Response to Reviewers — SENS�-26-06-RL-0906

“Wire-Level Interrupt-to-Decision Latency of On-Sensor MLC versus Host Inference on the NVIDIA Jetson Orin Nano: A Pre-Registered Measurement Study”

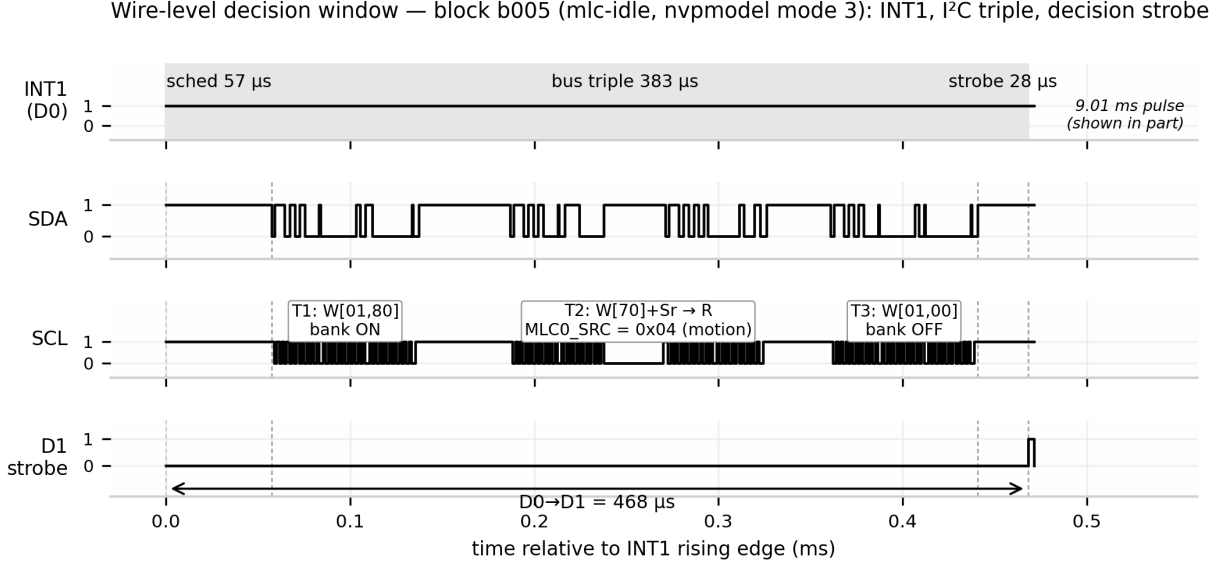
Point 3 — Absence of a wire-level timing diagram

“For a ‘wire-level’ study, the absence of logic-analyzer traces, or a timing diagram showing INT1/D1 edges and the three I^2C transactions, is a glaring omission. A single figure would have added enormous credibility.”

Response: We agree, and the omission is corrected with a measured SDA/SCL figure, not a schematic. The figure below is rendered by `code/analysis/fig_wire_timing.py` directly from the archived Saleae export for block b005 (mlc-idle, nvpmode mode 3) in the evidence package (Zenodo DOI 10.5281/zenodo.22950121). The four lanes are INT1 (D0), SDA, SCL, and the decision strobe D1. The decoder requires and finds exactly the four wire frames of the bank-switch read in the shown window: T1 W[01,80] (embedded-functions bank ON), T2 W[70] + repeated-start read of MLC0_SRC (=0x04, motion), and T3 W[01,00] (bank OFF). For the shown window ($t = 22.906$ s): INT1→first-byte scheduling 57.4 μ s, complete three-transaction triple 383.4 μ s, last-STOP→D1 strobe 27.5 μ s, D0→D1 468.3 μ s, with no foreign frame inside the triple. Campaign statistics remain in Table I and S1; this figure is the wire-level existence proof for the protocol those statistics decompose.

Manuscript changes: §VI.A pointer sentence added; the measured capture is provided as Fig. S4 in the supplementary material and is embedded in this response, generated reproducibly by `code/analysis/fig_wire_timing.py` from the archived capture; the extended candidate-mechanism discussion remains in S3 to preserve the 4-page limit.
